☒ BOARD No. 580708D-E/580709D-E

☒ DWG No. 943460F

CAD 10A83BAW00D	
<b>MADRIGAL</b>		audio laboratories, s.p.a.	
2081 south main street madrigal connection 06457 u.s.a.			
CONTENTS OF THIS PAGE ARE PROPERTY OF MADRIGAL - A Harman International Company			
DRAWN BY MM	DATE 07-24-2001	SHEET 1 OF 1	SIZE D
DESCRIPTION  NO. 432 LEFT/RIGHT CHANNEL AUDIO CHANNEL DAUGHTER		DWG No.  943460F

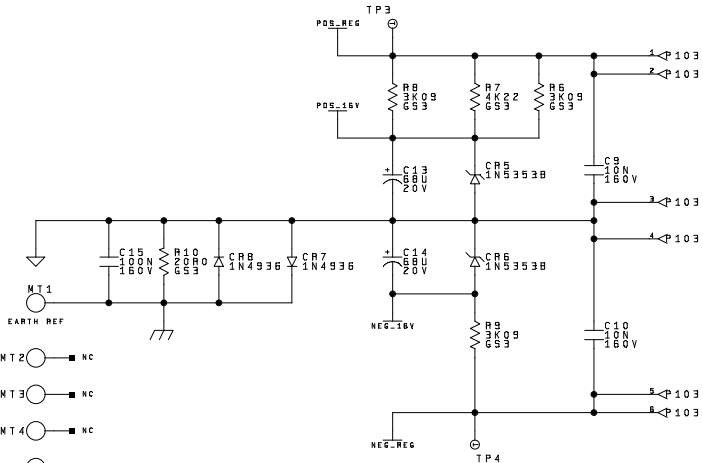
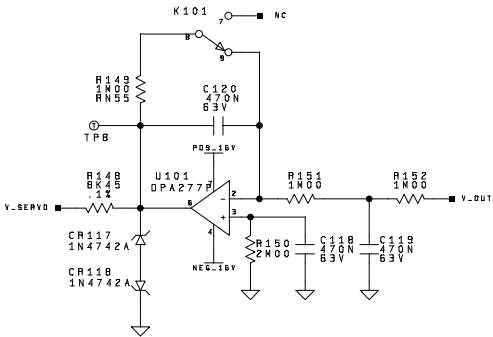
SYM	REVISION DESCRIPTION	DFTR	DATE
B	R12B,R131 WAS RNGO		9-12-2002
	DELETE R156,R127,R13B,C107,C110		5-2-2002
C	CHANGE PCB RCA DECAL		6-5-2002
D	MT6, MT7 WAS A PENNUT		8-22-2002
E	DRAWING NUMBER CORRECTION		9-12-2002
F	RECONNECT C207 C20B R220 R222		9-12-2002
	C204-POR WAS 10N, R226,R227 WAS 27KA RNB80		9-12-2002
	ADD C209,C210,R220,R222 WAS 60R4		9-12-2002
	R218,R224 WAS 634R,R219,R221 WAS 121R		11-18-2002
